Access Compliance Report

Public Rights-of-Way

Intersection ID: 4725	Main Street: STONEFIELD_DR	Cross Street: W_SUGAR_CREEK_RD	Location: S
ADA ID: B6C4D724A16B	Ramp Type: Perp	Initial Pass/Fail: Fail	Overall Compliance: No
			Severity Score: 33.75

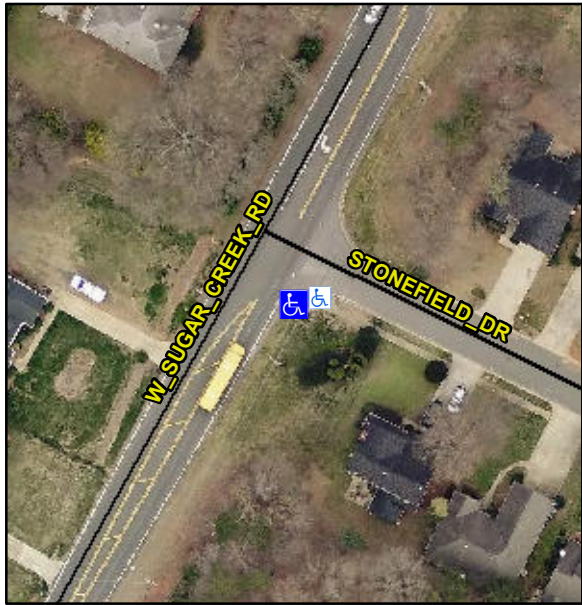
Codes/Mitigation Info/Possible Solution			Field Measurements/Component Compliance					
	Possible Solutions:		Compliance	Description	Data	Compliance	Description	Data
	Remove & Replace Entire Ramp.		N/A	Ramp Length (in)	85.0	No	Ramp Slope (%)	20.0
			No	Ramp Width (in)	36.0	Yes	Ramp XSlope (%)	2.0
			N/A	Flare Type LT	N/A	N/A	Flare Type RT	N/A
			N/A	Flare Slope LT (%)	N/A	N/A	Flare Slope RT (%)	N/A
			N/A	Flare Traversable LT?	N/A	N/A	Flare Traversable RT?	N/A
			N/A	Landing Length (in)	N/A	N/A	DWS Provided?	N/A
			N/A	Landing Width (in)	N/A	N/A	DWS Contrast?	N/A
			N/A	Landing Slope (%)	N/A	N/A	DWS Length (in)	N/A
			N/A	Landing X Slope (%)	N/A	N/A	DWS Full Width?	N/A
Surveyor Notes:		N/A	N/A	Landing Curb? (Y/N)	N/A	N/A	DWS Offset (in)	N/A
PROW/ADA:		Not Found, R304.5.1, R304.2.2	N/A	Shared Landing?	N/A			
			N/A	Gutter Ponding?	N/A	N/A	Gutter Slope (%)	N/A
			N/A	Gutter Lip Ht (in)	N/A	N/A	Gutter X Slope (%)	N/A
